# Access Compliance Report

## Public Rights-of-Way

| Intersection ID: 28237                  | Main Street: HIGHGROVE_ST | Cross Street: SOCIETY_ST                | Location: SW           |
| ADA ID: 5734B15AD58B                    | Ramp Type: PerpDiag       | Initial Pass/Fail: Fail                 | Overall Compliance: No |

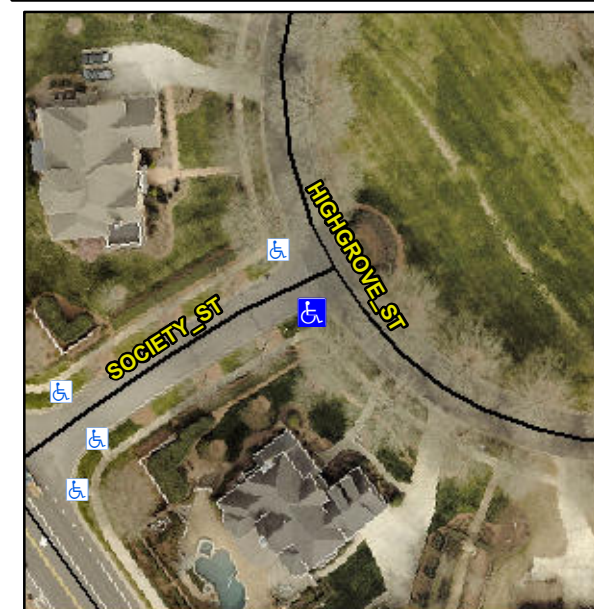
**R304.5.1, R304.2.2**

| Compliance | Description           | Data  | Compliance | Description                 | Data  |
|------------|-----------------------|-------|------------|-----------------------------|-------|
| N/A        | Ramp Length (in)      | 96.0  | No         | Ramp Slope (%)              | 8.8   |
| No         | Ramp Width (in)       | 47.5  | Yes        | Ramp XSlope (%)             | 1.6   |

**Remove & Replace Curb Ramp With Two New Directional Ramps or Equivalent.**
